Response to the Reviewers' Comments

The authors would like to thank the reviewers for the precious comments and suggestions on the technical contents and presentation of our manuscript “Runtime Power Management of Battery Electric Vehicles for Extended Range with Consideration of Driving Time,” submitted to IEEE Transactions on Very Large Scale Integration (TVLSI.) This revised manuscript has been greatly improved thanks to the reviewers’ invaluable advices. We have revised the manuscript faithfully following the reviewers’s comments. We include the newly added or significantly modified parts in the revised version of the paper also in Response to Reviewers. We highlight the important technical content changes and set those parts in a red color in the revised paper.

Fig. 1: (a) Range-speed experimental data for Chevrolet Bolt [36] and (b) comparison with simulation results of the proposed EV power model.

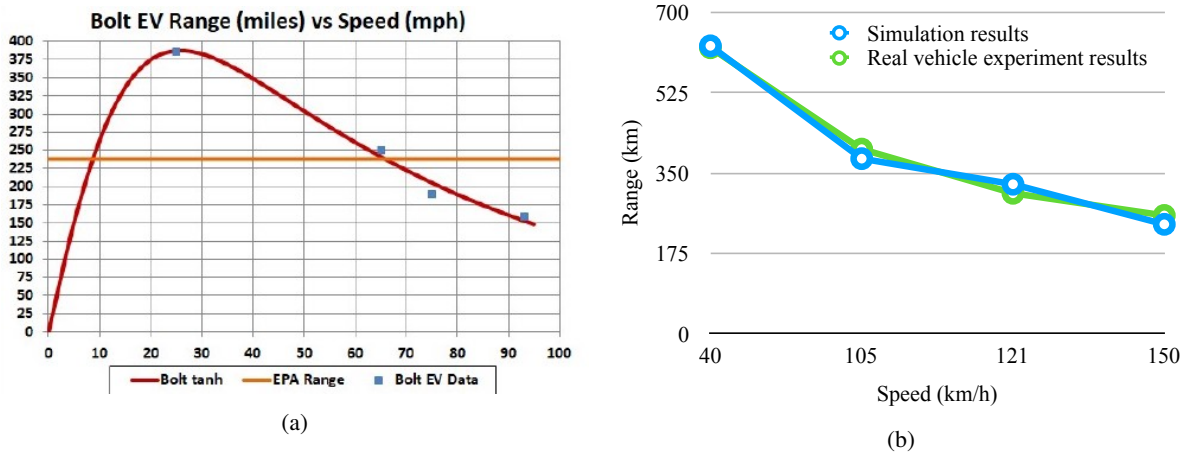
R1-C2 It is not clear how to validate the power model of EV. As the author mentions that accuracy of power model is quite important, it is good to see the power model in this paper can be validated by some real measurement results.

R2-C1 The paper claims that the proposed BEV power model is more accurate than those in the literature. While the results in Section V demonstrate the benefits of the proposed model and in some way indirectly show its accuracy, it would be good to have a direct comparison of model accuracy between the proposed model and those in literature, e.g., based on simulations as in Fig. 1.

In this paper, we use the same EV power model equation in [1], which has been proven to be accurate as long as the coefficients are appropriate. However, the model coefficients in [1] are only for low-speed, ultra light-weighted EV (a half metric Ton). However, we would like to demonstrate a more practical results that are applicable to production EVs. Therefore, all the coefficients should be updated for production-scale EVs in this paper.

Here goes how we extracted correct coefficients of the EV power equation. We use a vehicle simulator that supports EV as well, ADVISOR, to extract the coefficients of new vehicles starting from known vehicle specifications such as the aerodynamic resistance, rolling resistance, curb weight, and so on. Such data is often published in the users' manual, website and so forth. We further use the vehicle performance data such as the top speed, maximum acceleration, and so on, which are also available on the manuals and website. We iteratively run ADVISOR and derive the model coefficients so that all the known values match among each other. We evaluate the model accuracy with the range-speed real vehicle experiments as shown in Fig. 1(a), which has been published by [32], [33], [34], [35], [36]. We further refine the coefficients until all the available data values match well. Finally, the derived EV power model well matches with the range-speed experimental data as shown in Fig. 1(b) as well as the top speed and maximum acceleration, setting the aerodynamic resistance, rolling resistance, curb weight, etc. with the known (fact) values. The errors of the range-speed simulation is merely 1.4%, the time to approach 60 mph at departure is 7.8%, and the top speed is 3.0%, respectively. We revised the manuscript adding the following paragraph with a new figure in Section III-A on page 3 and 4.

We use ADVISOR to extract the model coefficients of new vehicles starting from known vehicle specifications such as the aerodynamic resistance, rolling resistance, curb weight, and so on. Such data is often published in the users manual, website and so forth. We further use the vehicle performance data such as the top speed, maximum acceleration, and so on, which are also available on the manuals and website. We iteratively run ADVISOR and derive the model coefficients so that all the known values match among each other. We evaluate the model accuracy with the range-speed real vehicle experiments as shown in Fig. 1(a) [32], [33], [34], [35], [36]. We further refine the coefficients until all the available data values match well. Finally, the derived EV power model well matches with the range-speed experimental data as shown in Fig. 1(b) as well as the top speed and maximum acceleration setting the aerodynamic resistance, rolling resistance, curb weight, etc. with the known values. The errors of the range- speed simulation is merely 1.4%, the time to approach 60 mph at departure is 7.8%, and the top speed is 3.0%, respectively. The model coefficient extraction result shows as in Fig. 2. The normalized root-mean-square deviation is 5.1%. Table I summarizes the model coefficients of (5) for Chevrolet Bolt.

Fig. 12: Comparison of *EDP* for various energy-aware-velocity planning methods.

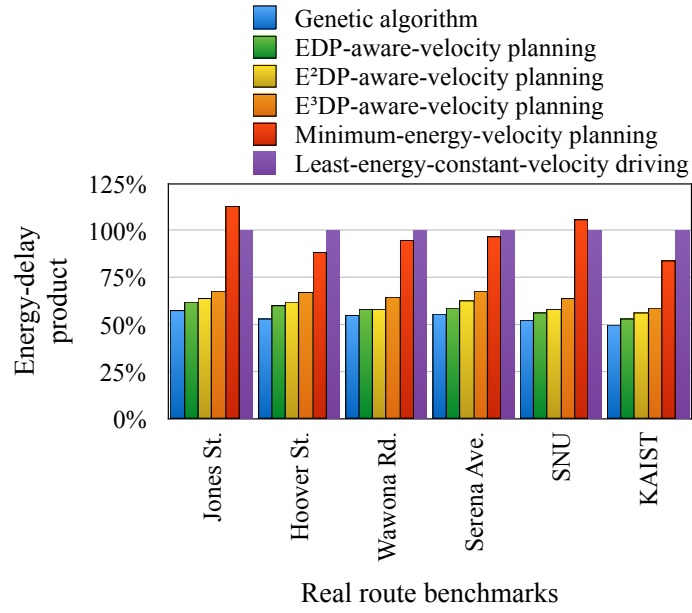
R1-C3 The optimality of the proposed scheduling algorithm is unclear. The author should add several paragraphs to discuss this topic. It is also to see the comparison baseline is well accepted to show the advantage of the proposed algorithm.

R2-C5 The baseline for comparison is the least-energy-constant-velocity scheme. As the optimal velocity significantly depends on road slope, such scheme is obviously sub-optimal. It would be interesting to see how the proposed method compares with a simple extension of least-energy-constant-velocity, where a constant velocity is calculated for each segment with the same slope.

In this revised manuscript, we did spend an extended period of time and added a new content how close the proposed heuristics method is to the true optimal, comparing with the results of Genetic algorithm (GA). GA can hardly be used for a practical solution method as its time complexity is not suitable for real applications. We use the GA results as a golden reference to evaluate the optimality of the proposed heuristics.

Fig. 12 shows EDP of the least-energy-constant-velocity driving, the velocity planning with EDP , E^2DP and E^3DP as a metric on various road benchmarks and the minimum-EDP-velocity planning with GA. The proposed velocity planning results in up to 47% improvements of EDP compared with the least-energy-constant-velocity driving. The improvements occur especially when the slope of the uphill is steep. The driving velocity on a flat road is faster than that of the least-energy-constant-velocity driving at the expense of relatively little energy to save driving time. Then, the velocity decreases when climbing the following uphill to spend less motor torque, which saves more energy.

In addition, the proposed EDP-aware-velocity planning is merely 7.8% higher than the true EDP-minimum-velocity planning on average. Through this results, we confirm that the results of the proposed heuristics are close enough to the true optimal solutions.

Fig. 13: Histogram of (a) velocity and (b) acceleration for various energy-aware-velocity planning methods.

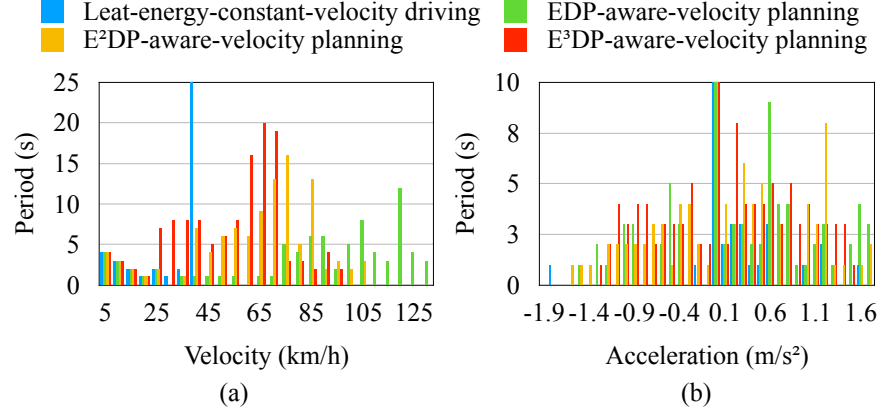
R2-C2 It would be good to have more discussion on the assumptions of the approach and the experiments, e.g., how much can the velocity be changed in practical scenarios without impeding traffic and causing unsafe situations (also depending on the road conditions and whether it is urban or rural environment I suppose). Currently, there only seems to be one constraint on not slower than 10 km/h.

R3-C2 Three different energy-delay product metrics are given in the paper. Can you recommend which one would be the best practical scenarios?

Of course, the least-energy-constant-velocity driving results in the least velocity and acceleration change, and thus it provides the maximum predictability and comfort. Compared with the least-energy-constant-velocity driving, the proposed methods, which are aware of EDP , E^2DP and E^3DP , keep changing the velocity by the road slope change and thus may impede traffic as the reviewer pointed out. It is unlikely to incur dangerous situations, but harsh braking and fast deceleration may cause uncomfortness of passengers and potentially disturb safety assurance. In the revised manuscript, we add new analysis of the baseline and proposed methods (EDP , E^2DP and E^3DP) about the velocity and acceleration change. The newly added analysis is a histogram analysis of velocity and acceleration. We quantize the velocity and acceleration values and make a histogram as shown in Fig. 13. Thanks to the reviewers comment, we had a chance to deeply look into the histogram analysis and revised the driving condition constraints.

We previously constrained that the EV should not drive too slow to avoid bothering traffic with the minimum speed of a 10 km/h. However, such velocity constraint is not realistic even in a city driving as the reviewer pointed out. We do agree on that more realistic minimum speed constraint is desirable, and thus we revised the constraint from 10 km/h to 25 km/h. Even with the new minimum speed constraint, we exhibit the same amount of gains with the proposed methods. After carefully analyzing the acceleration histogram, in this revised version of the manuscript, we newly enforce the minimum acceleration not lower than 0.4 m/s^2 when the EV starts from a stop sign or a traffic light until the velocity reaches to 25 km/h not too bother traffic flow. If the EV accelerates at a 0.4 m/s^2 , it would take 15 seconds to reach a 25 km/h speed. The previous version of the manuscript used the maximum acceleration limited by the motor torque: a 4.7 m/s^2 on a flat road. However, such a fast acceleration negatively affects to the power consumption as well as passenger comfortness. The revised version of the manuscript limits the maximum acceleration to 1.7 m/s^2 as shown in Fig. 13(b), which is the same as the maximum acceleration of compact cars designed to be primarily used in urban areas (15 seconds of 0 to 100 km/h time.)

We assume that the EV should not drive too slow to avoid bothering traffic with the minimum speed of a 25 km/h. Even with the minimum speed constraint as lower than 25 km/h, we exhibit the same amount of gains with the proposed methods. After carefully analyzing the acceleration histogram, we newly enforce the minimum acceleration not lower than 0.4 m/s^2 when the EV starts from a stop sign or a traffic light until the velocity reaches to 25 km/h not too bother traffic flow. If the EV accelerates at a 0.4 m/s^2 , it would take 15

seconds to reach a 25 km/h speed. The maximum acceleration is limited by the motor torque: a 4.7 m/s^2 on a flat road. However, such a fast acceleration negatively affects to the power consumption as well as passenger comfortness. We limit the maximum acceleration to 1.7 m/s^2 as shown in Fig. 13(b), which is the same as the maximum acceleration of compact cars designed to be used primarily used in urban areas (15 seconds of 0 to 100 km/h time).

We quantize the velocity and acceleration values and make a histogram as shown in Fig. 14 (Please refer R2-A2). For the EDP -aware-velocity planning, it is used when the deadline is the most important concern. Therefore, it is guided to drive at a speed of 75 to 130 km/h mainly regardless of the road slope. On the other hand, the E^2DP - and E^3DP -aware-velocity planning methods are used when the remaining battery state of charge is more concerned than the deadline. It is guided to drive at an energy-efficient speed along a road slope. Particularly, the E^3DP -aware-velocity planning method is used when the state of charge is more concerned, and the driver should find the nearby charging station. It is guided to decelerate to 25-40 km/h when climbing hills to further reduce energy consumption.

Fig. 9: Benchmark altitude.

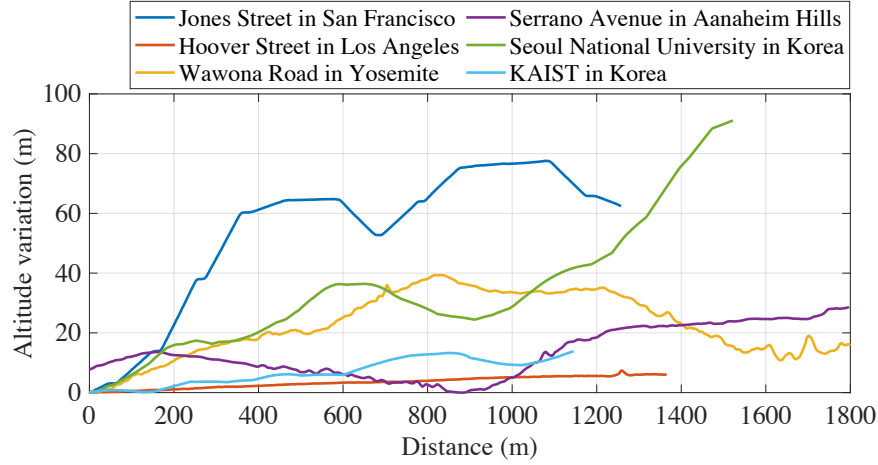
R2-C3 Related to the last point, it would be good to have more discussion on the road benchmarks, e.g., how they are generated and how representative they are. The optimization results significantly depend on road slope. It would be good to use a variety of real road segments for testing.

R2-A3 We appreciate the reviewer’s comment and added six new real routes from various locations in the world. First two routes consists of road segments in cities (San Francisco and Los Angeles, the two representative city landscapes such as hills and flat roads, respectively). The second two routes are road segments in mountain areas (Yosemite and Anaheim Hills in California.) The last two routes are university campus road segments. The details of route data is summarized in Table II and Fig. 9, which visualize the altitudes of the benchmarking routes.
